**Addendum No. 2  
To the Plans, Specifications, Proposal and Contract**

**City of Kirkland  
Fire Station 24  
9824 NE 132<sup>nd</sup> ST, Kirkland WA 98034  
CIP # PSC 3002 200  
JOB # 32-20-PW**

ISSUED THIS DATE: August 10, 2020

REFERENCE SHEET:  
**E2.1**

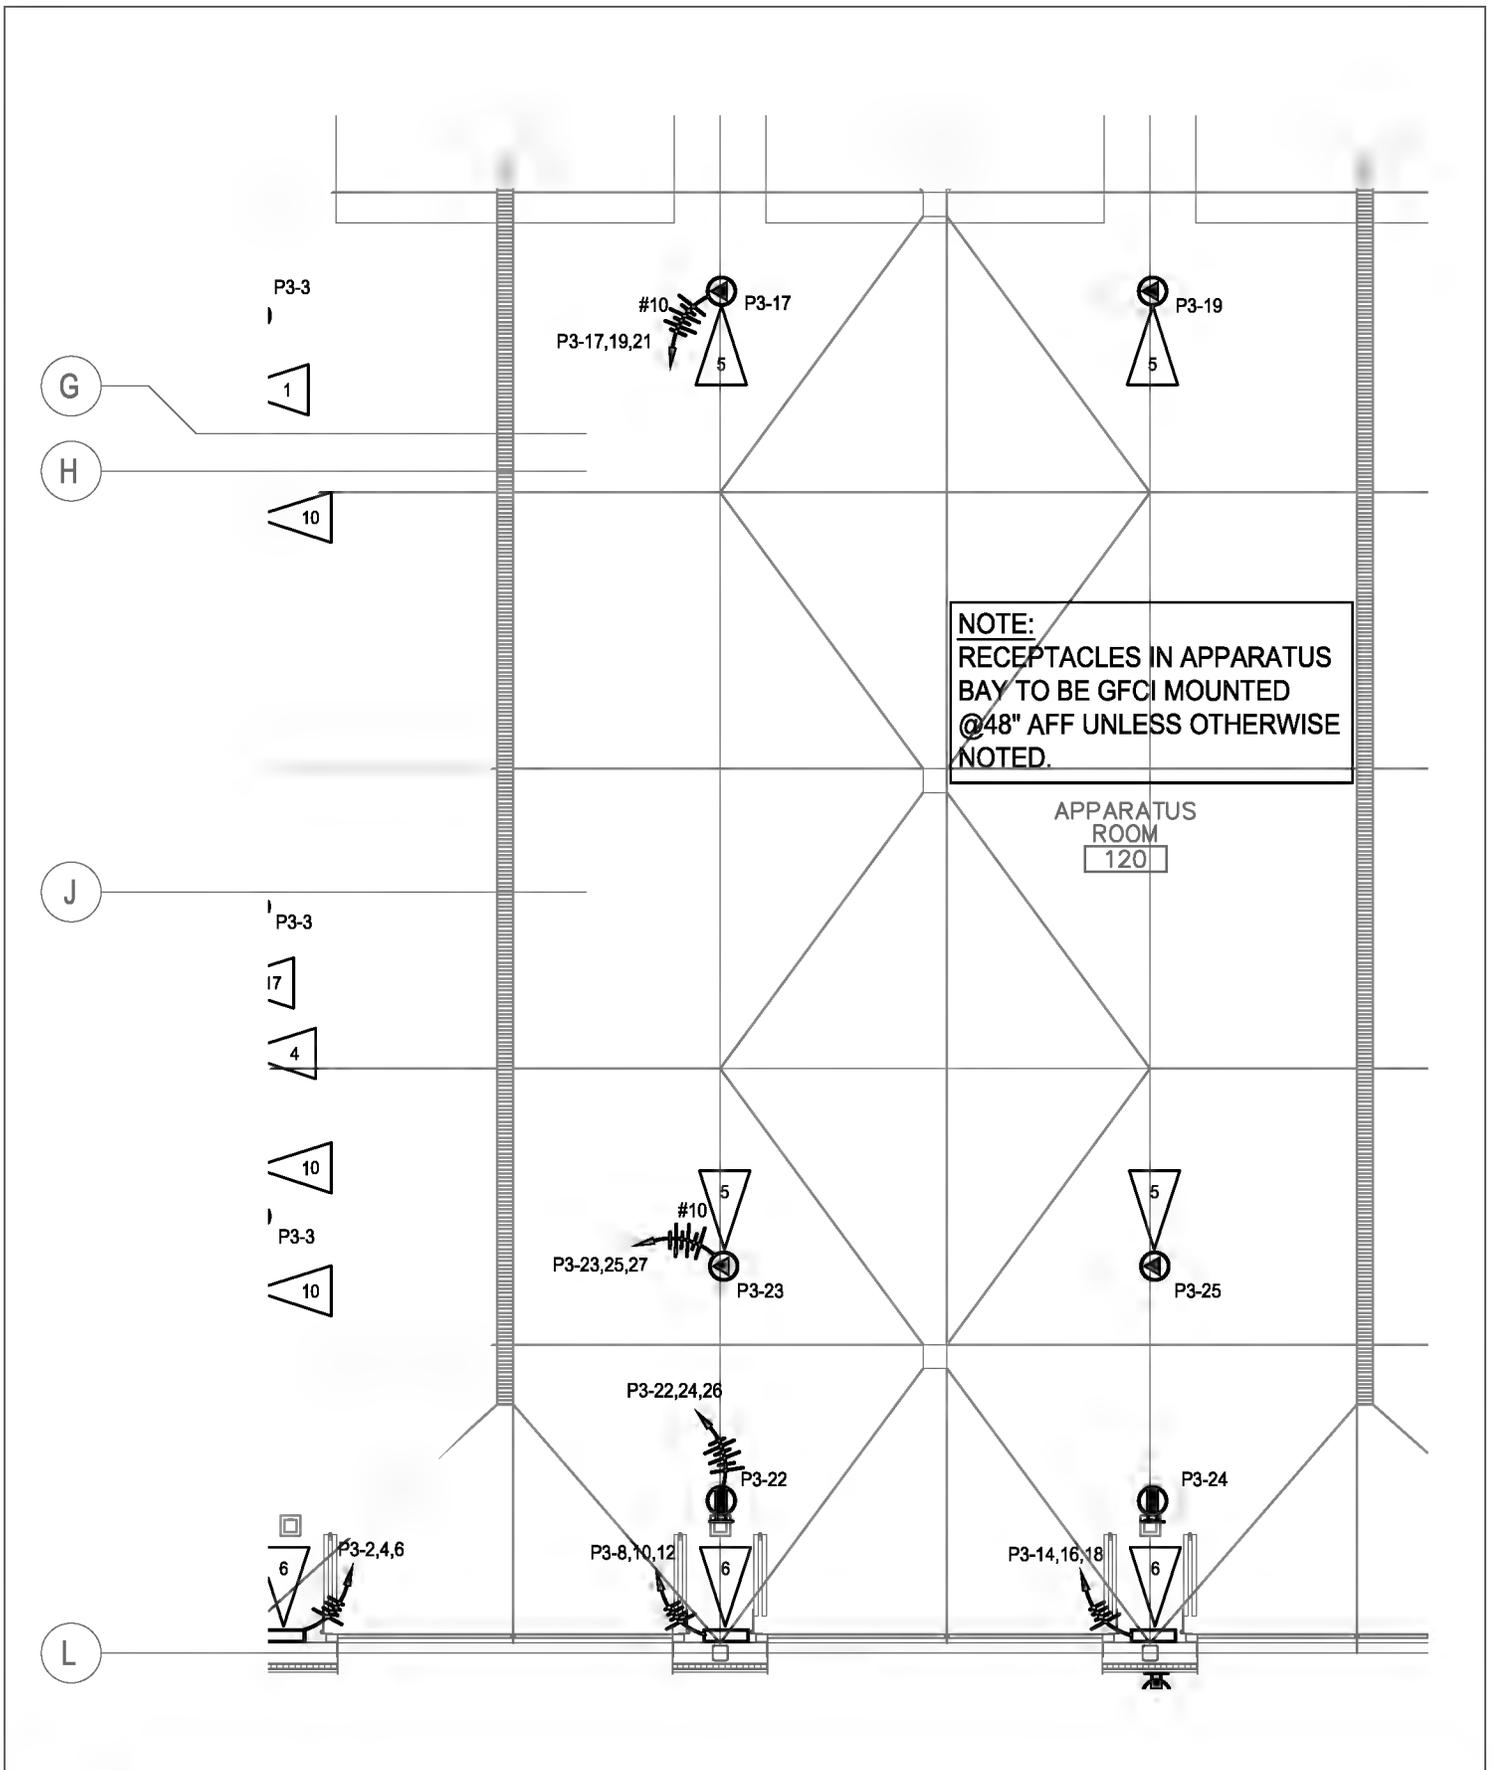
- a. Revise receptacle on north wall of FF WORK ROOM 103 from switched duplex to switched double duplex per attached sketch AD2 ESK-3.
- b. Revise apparatus bay drop cord circuit wire size from #12 to #10 per attached sketch AD2 ESK-4.
